NOTICE OF ADDENDUM
ADDENDUM #1

Subject: **Ticket Lobby Center Video Wall and Two (2) Flight Information Display Screens (FIDS): Equipment and Removal/Installation Services; Request For Proposals # BD-2017-003**

The Columbus Regional Airport Authority (CRAA) hereby issues an addendum to the subject solicitation:

ATTACHMENT C: EXISTING VIDEO WALL INFORMATION

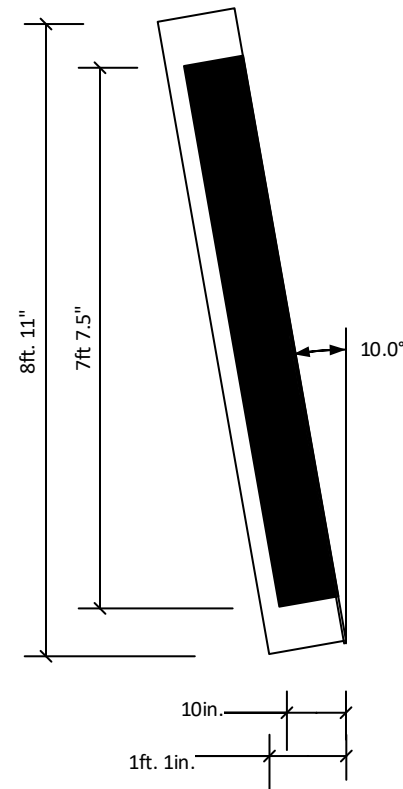
- Correction to the RFP due date mentioned on Page 3 of the solicitation (attached below). Due date remains: **September 20, 2017**.
- Correction to two specification measurements within the first page of Attachment C of the RFP, Page 33 of the solicitation (attached below).

4x12 Video Wall			
48x	NEC X461UN Display Panels		
	Weight:	64.6lbs/	2,325lbs
	Est. Power Consumption	200watt/	7,200watt
48x	Chief ?? Wall Mounts	??lbs
